Work Order ID 160715

Item Name: Strut Tube

ENGINEERING CHANGE NOTICE NO.

DWG TITLE: STRUT ASSY

SHEET 2, ZONE D4 IS:

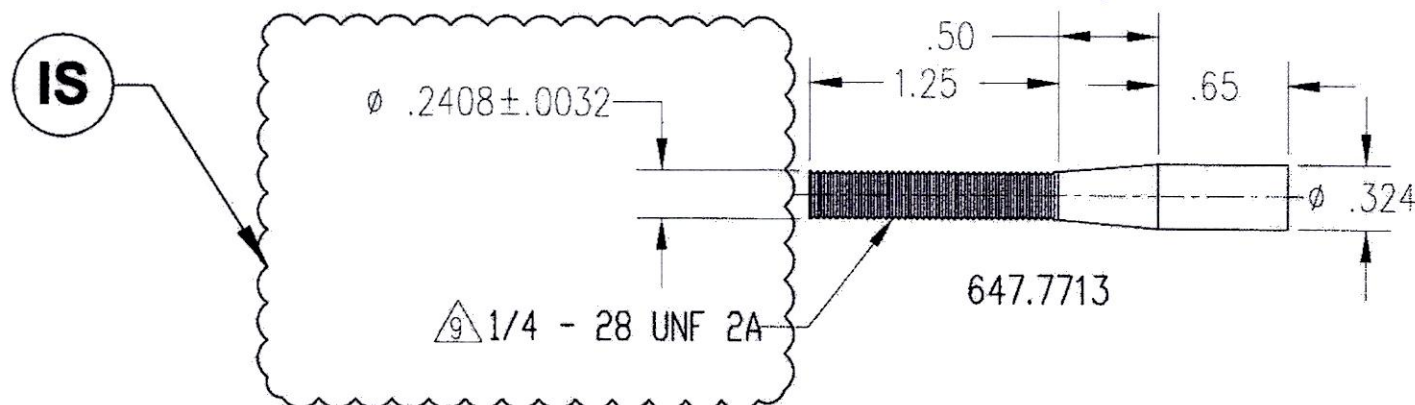
REASON: REVISED DIMENSION
